REQUEST FOR TECHNICAL REVISION (TR) COVER SHEET

Asphalt Paving Co., Ralston Quarry M-1974-086
Technical Revision – Modifications to Slide Repair Designs and Plans

**Limited Geotechnical Evaluation
Slope Stability and Remediation Approach
Ralston Quarry
Jefferson County, Colorado
Revised6**

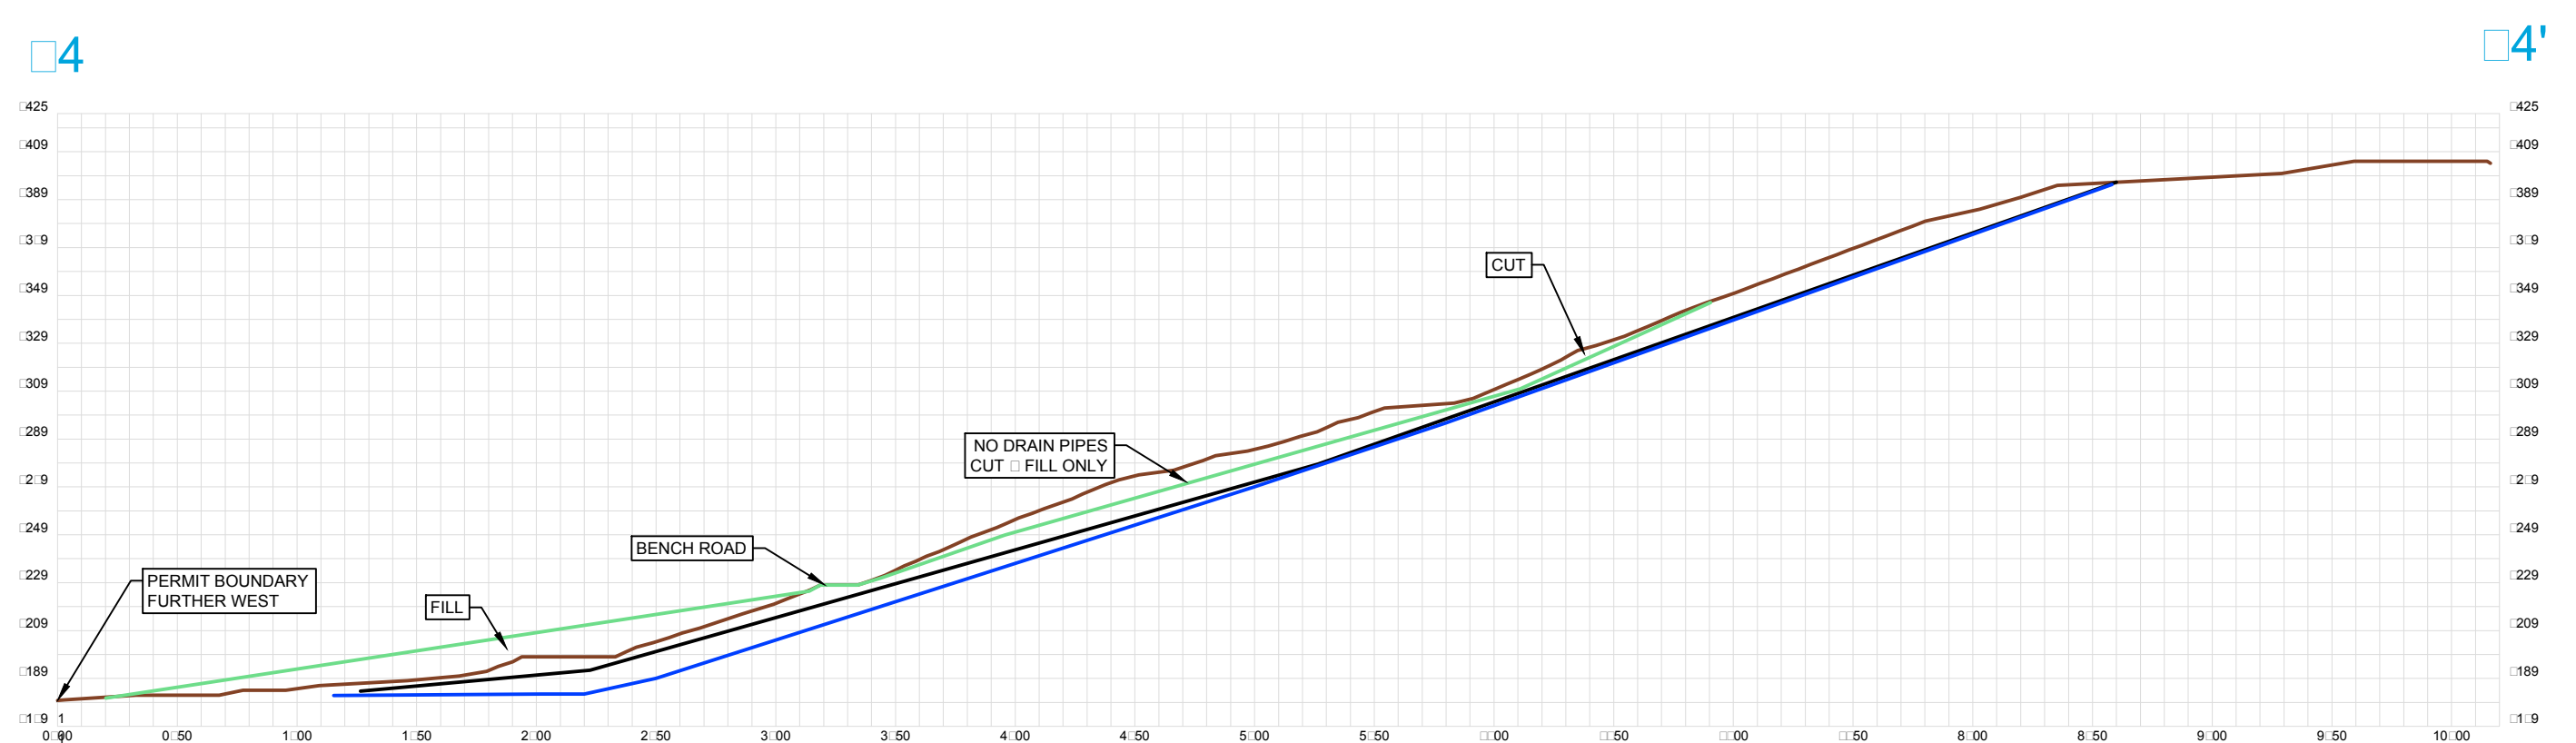
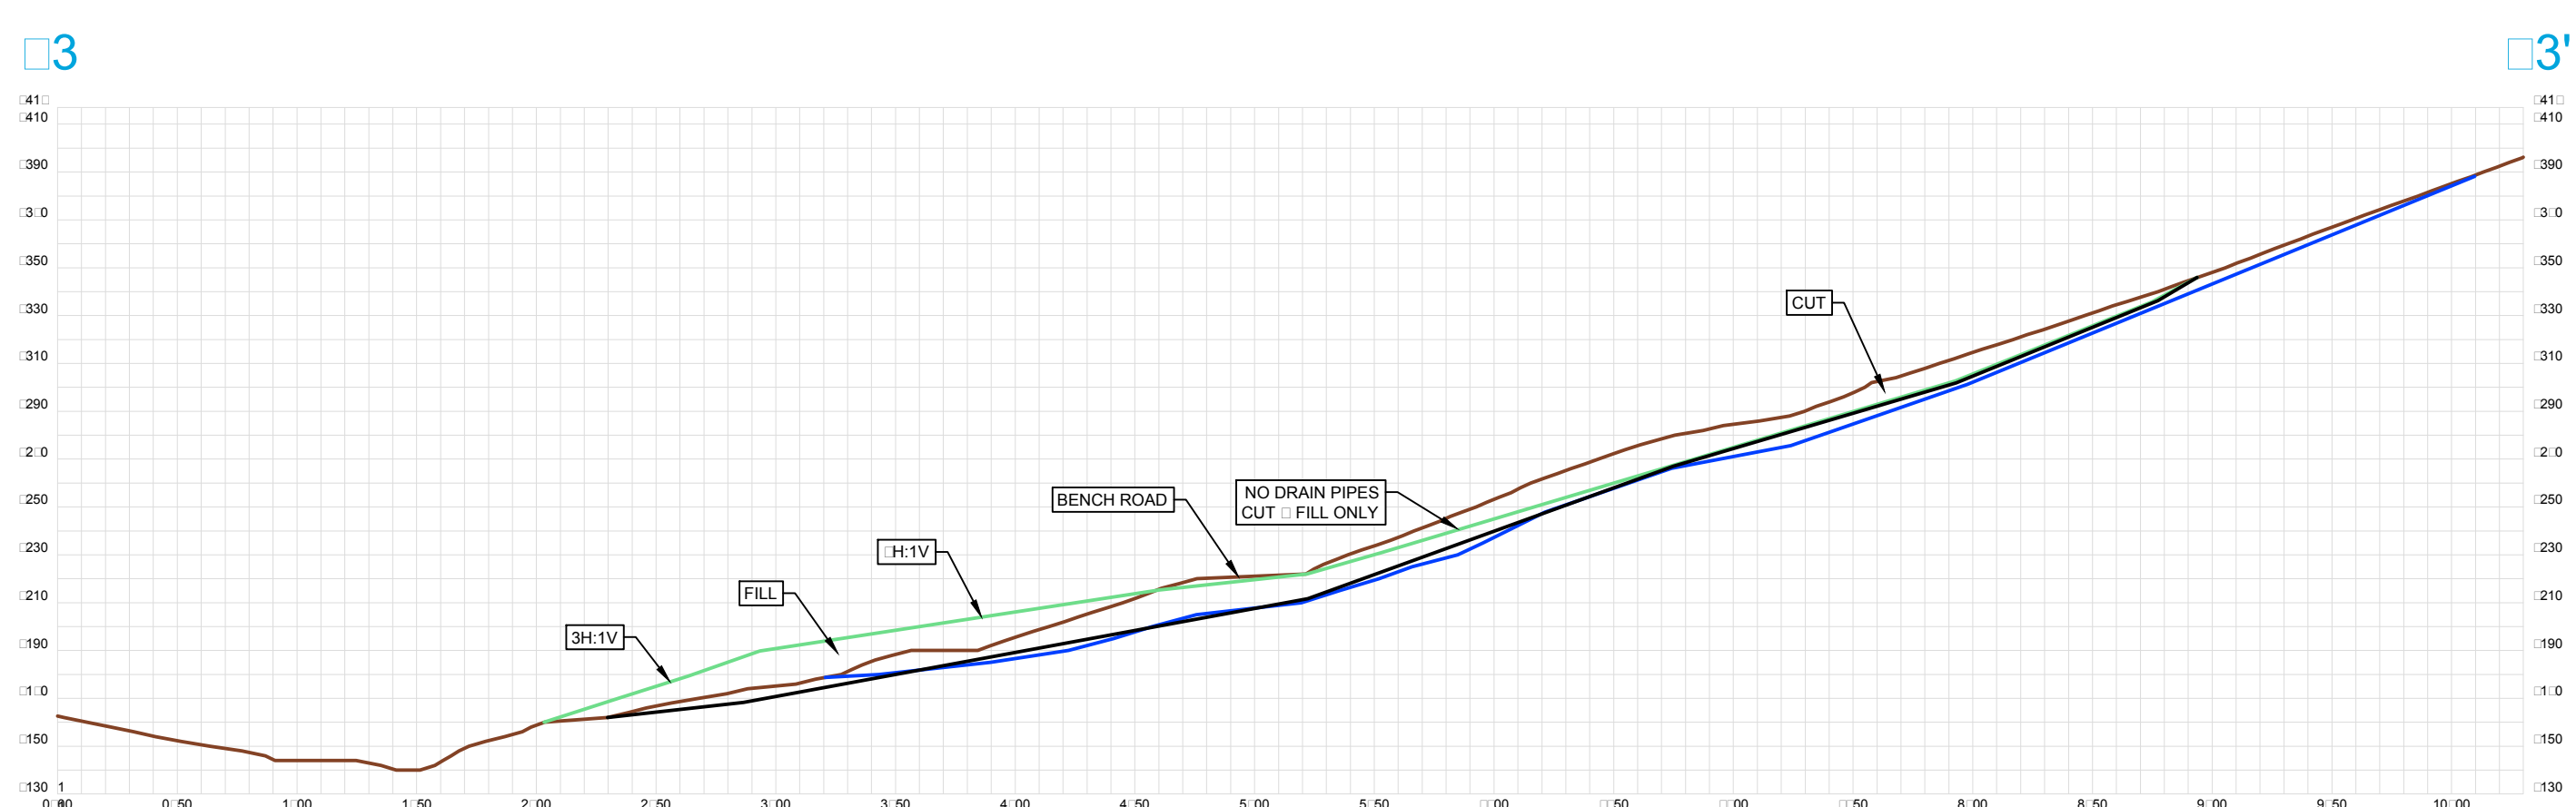
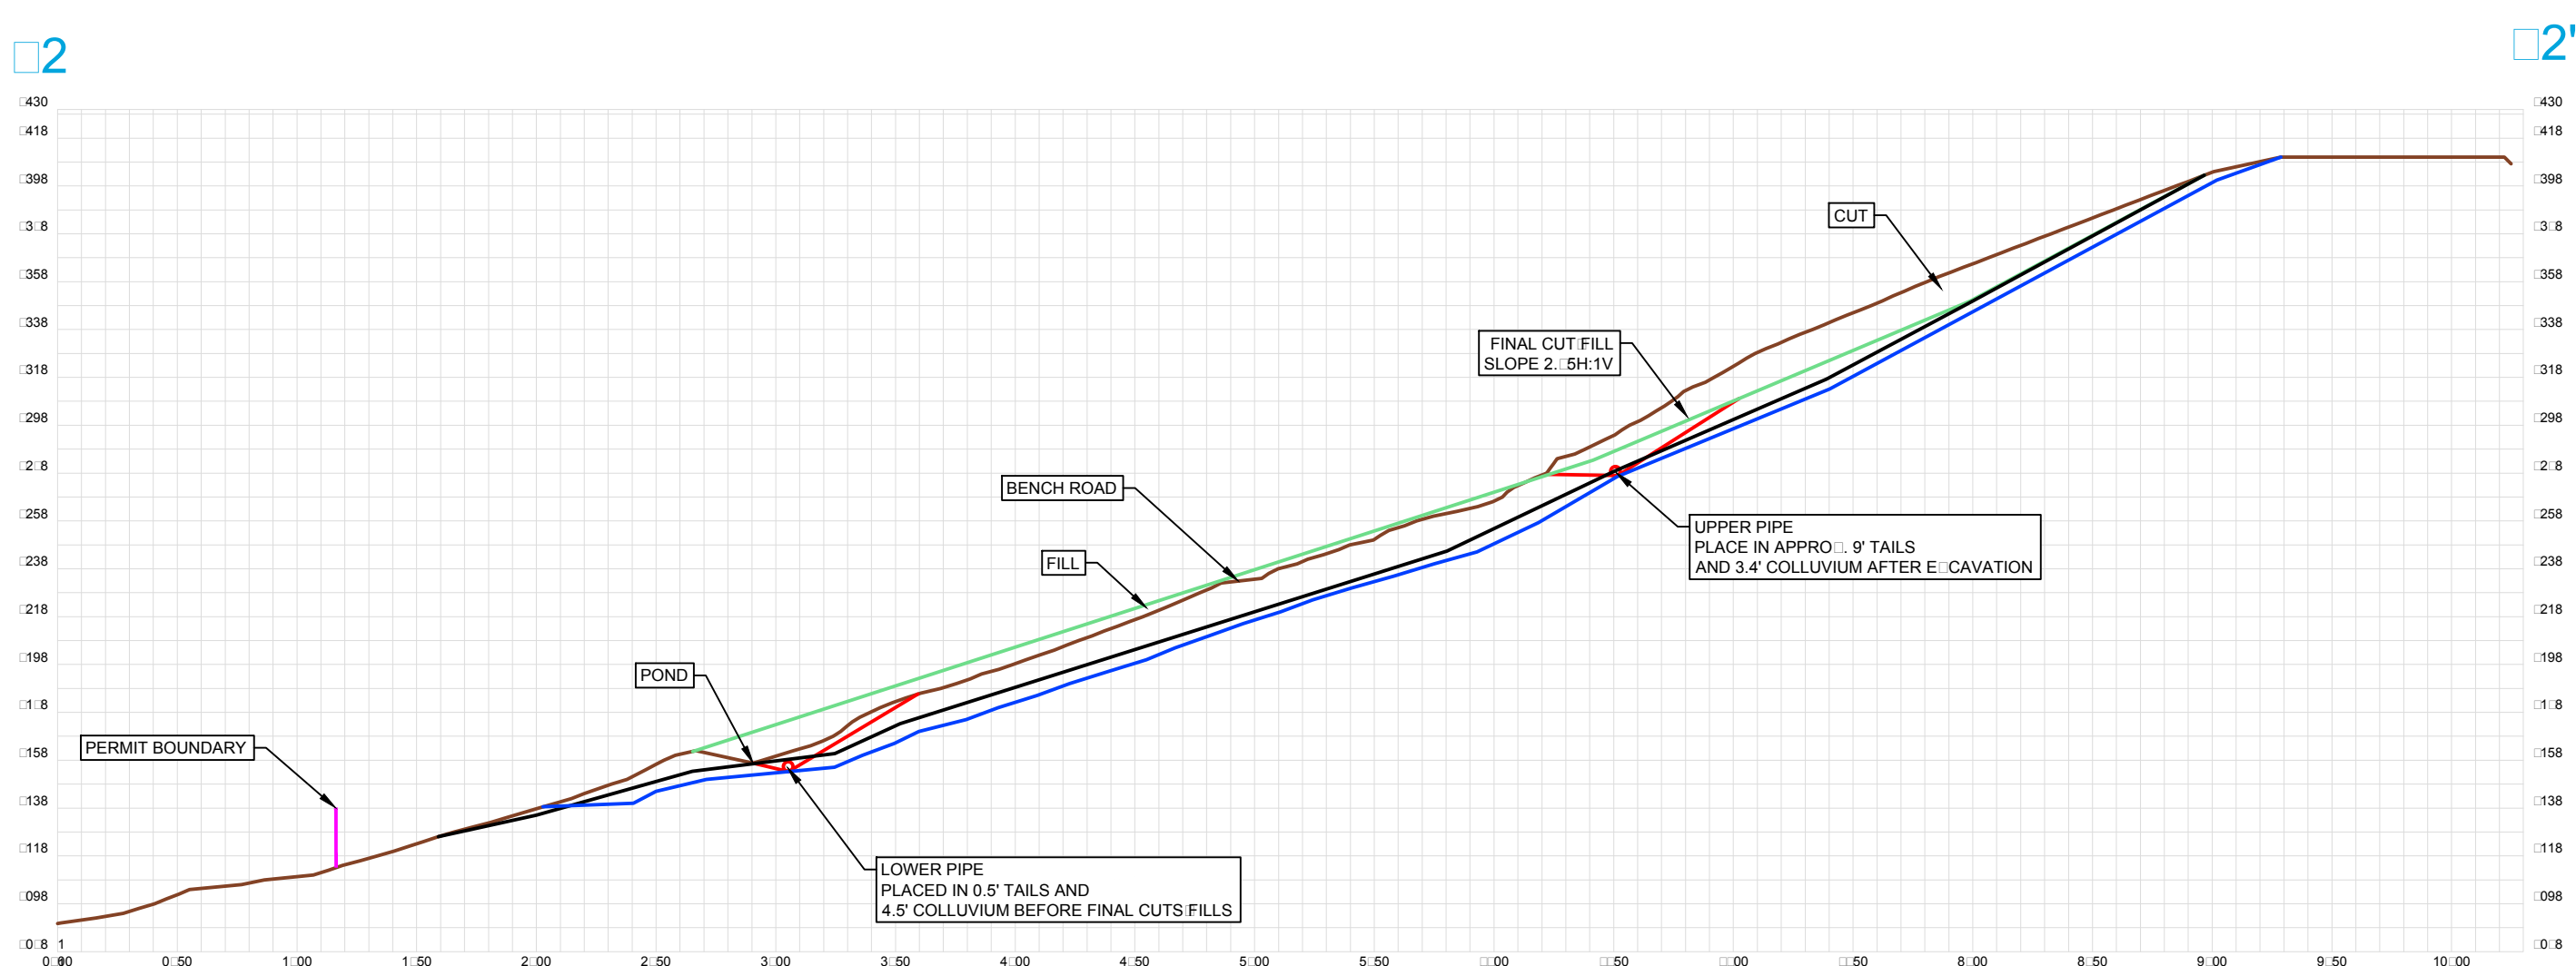
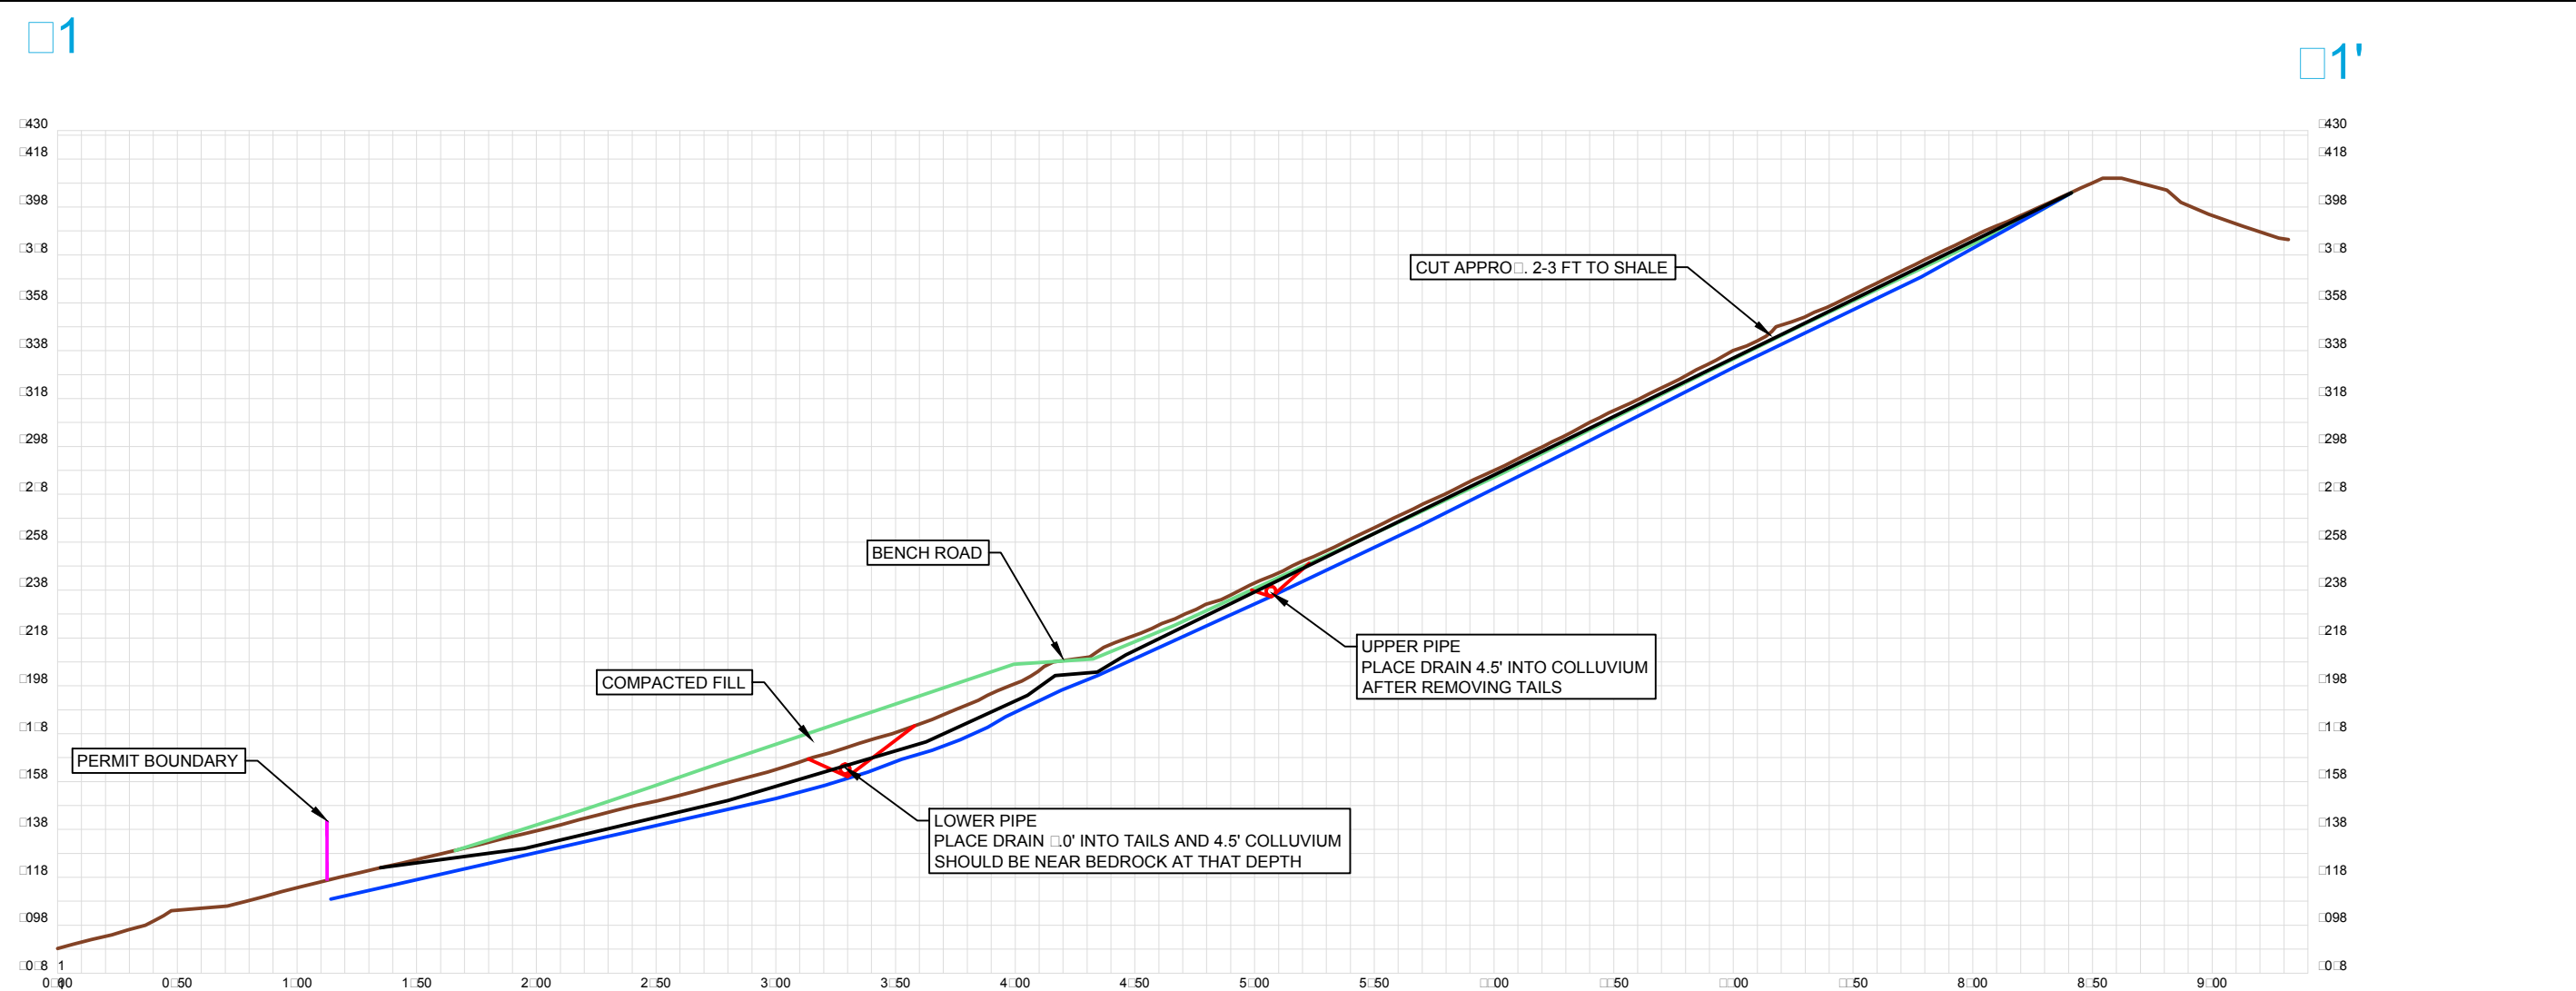
Zone 3 consists of the 2018 slide and surrounding ground. This area was evaluated in detail by Ground Engineering to determine the most effective and efficient way to accomplish slope stability without construction safety risk or unnecessary ground disturbance. Cross sections were developed perpendicular to the slope and different designs were evaluated along these cross sections in an iterative process to determine the appropriate repair design. Ground Engineering's attached report shows the slope stability that is achieved with these designs. Map F-2 shows the existing and final slope cross sections.

Zone 3A will not require the installation of subsurface drains, as regrading of this section of slope will be sufficient to achieve a safety factor of 1.3. Two cross sections through this area were analyzed and can be seen on Map F-2.

Zone 4 consists of areas north of the 2018 slide that contain a previous, smaller slide area. This area was evaluated in detail by Ground Engineering to determine the most effective and efficient way to accomplish slope stability without construction safety risk or unnecessary ground disturbance. Cross sections (X1-X1' and X2-X2' on Map F-2) were developed perpendicular to the slope and different designs were evaluated along these cross sections in an iterative process to determine the appropriate repair design. Ground Engineering's attached report shows the slope stability that is achieved with these designs is 1.4 and 1.2. Map F-2 shows the existing and final slope cross sections.

Subsurface drainage systems will be installed in this zone. Their arrangement can be seen on Map F-2.

Map C-4 and F-2 show the revised subsurface pipe locations. None of the stormwater designs on Map C-4 have been changed from the approved permit designs.
